**NATIONAL RAILROAD PASSENGER CORPORATION
NORTHEAST CORRIDOR
NEW YORK - WASHINGTON
SUMMARY BULLETIN ORDER No. NYW1-23SUM
Effective 12:01 AM, Monday, December 1, 2025**

INDEX OF RULE / SI CHANGES OR MODIFICATIONS CONTAINED IN THIS BULLETIN ORDER

1. Chrysler Yard

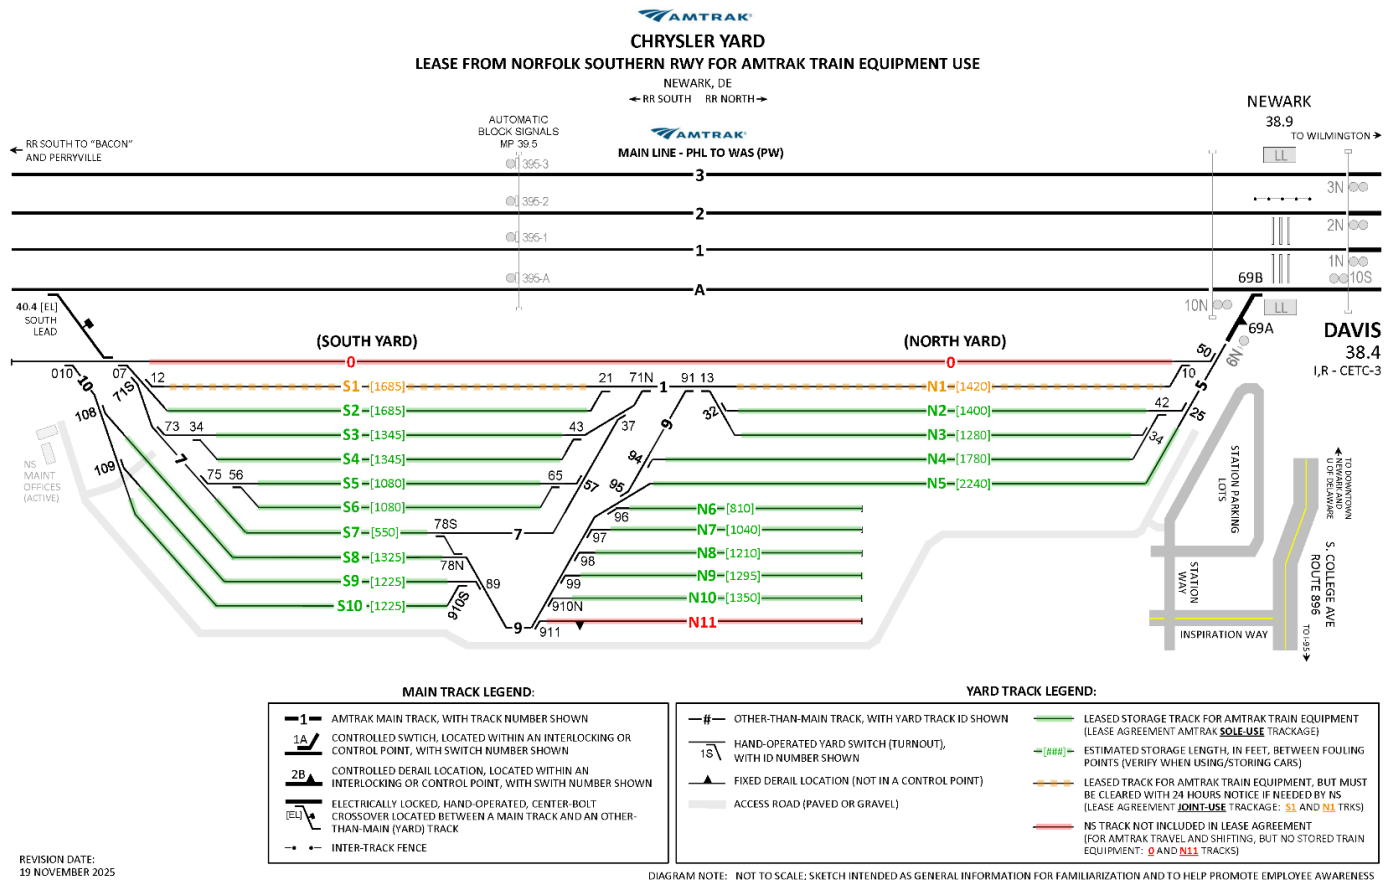
NS Chrysler Yard is now available for Amtrak use. The Yard is adjacent to No. "A" Trk at MP 38.9.

Trains and equipment can access the yard from No. "A" Trk at the 10S Signal at Davis Interlocking or on the south end of the yard at the electric lock switch on No. "A" track at MP 40.4.
